# Development Committee

## Staff Report

June 18, 2014

<b>Case No:</b>	14Devplan1064
<b>Project Name:</b>	Proposed Personal Care Facility
<b>Location:</b>	9107, 9109 & 9113 Taylorsville Rd.
<b>Owner(s):</b>	9107 Taylorsville Road, LLC.
<b>Applicant:</b>	Turtle Creek Management, Inc.
<b>Representative(s):</b>	Bill Bardenwerper, Bardenwper, Talbott & Roberts
<b>Jurisdiction:</b>	Forest Hills
<b>Council District:</b>	18 – Marilyn Parker
<b>Case Manager:</b>	<b>Latondra Yates, Planner II</b>

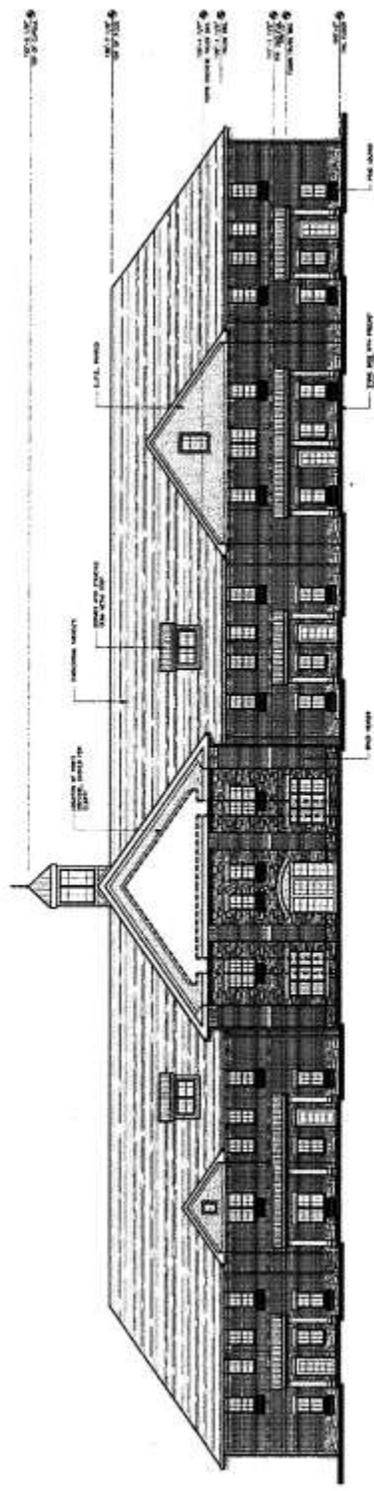
STAFF: The proposed use appears to be compatible with the surrounding mix of uses. However, significant encroachment of structure, parking and maneuvering is proposed, particularly on the west side, into the required landscape buffer, is proposed.

Staff's analysis of the standards of review support the granting of RDDDP, with recommendations that the site layout be revised to provide more of the required setback and LBA, particularly to the west. The RDDDP violates 6 guidelines of the Comprehensive Plan. Substantial encroachment of the building, parking and maneuvering, particularly on the west side, into both the required setback and LBA are proposed.
